I.M. WEST ADDITION #1 (COURTYARD INFILL)

Michigan State University

Project Number CP03111

BULLETIN NO. 1

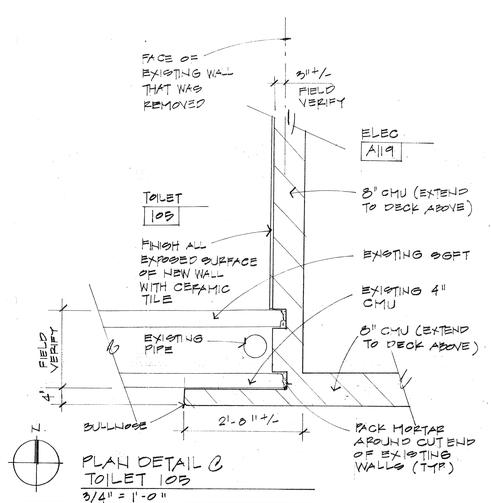
TMP Reply to Barton Malow / Clark RFI No. 0018:

1. Provide new 8-inch CMU wall between Women's' Toilet 105 and Electrical A119. Extend wall tight to underside of deck construction above. Enclose cut end of existing chase wall at southeast corner of Toilet Room 105 as indicated on attached sketch.
2. Provide ceramic tile finish (floor to ceiling) on new wall construction at Women's Toilet 105. Ceramic tile will be American Olean, 4-1/4" x 4-1/4", #95 Snow Mist.
3. Remove and reinstall toilet stall grab bars and other miscellaneous equipment as required by new construction.
4. Replacement wall is required by demolition contractor's error. Additional costs for replacement construction will not be borne by the Owner.

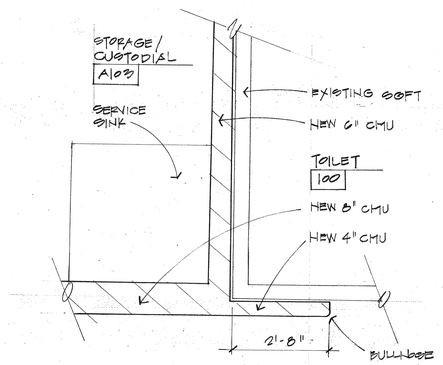
TMP Reply to Barton Malow / Clark RFI No. 0021:

1. Provide 6-inch CMU wall at east side of Storage/Custodial A103 to conceal unfinished side of existing SGFT partition, and to conceal new plumbing vent stack, per attached sketch.
2. Also note detail for new 8-inch CMU wall at south side of Storage/Custodial A103 to replace existing unstable wall removed during demolition.
3. Please submit itemized quotations for this additional work, for review and future Change Order.

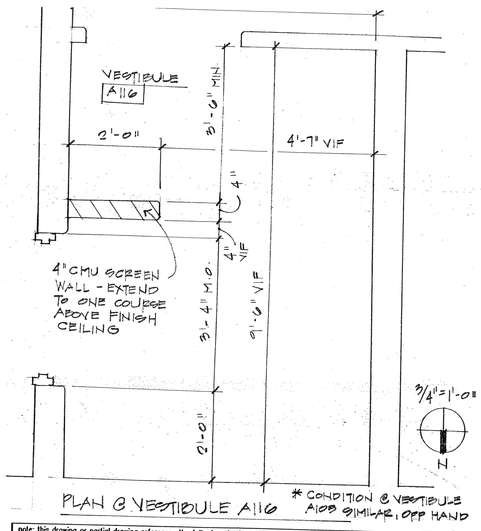
ITEM NO. 22: Refer to Drawing A1.1A (re-issued):

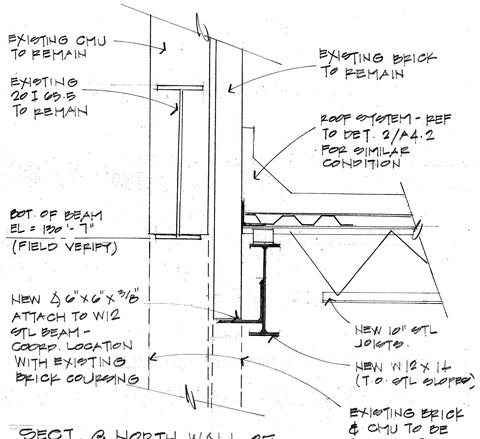
SECT. @ NORTH WALL OF DUCT PLENUM A202
1 1/2" = 1'-0"
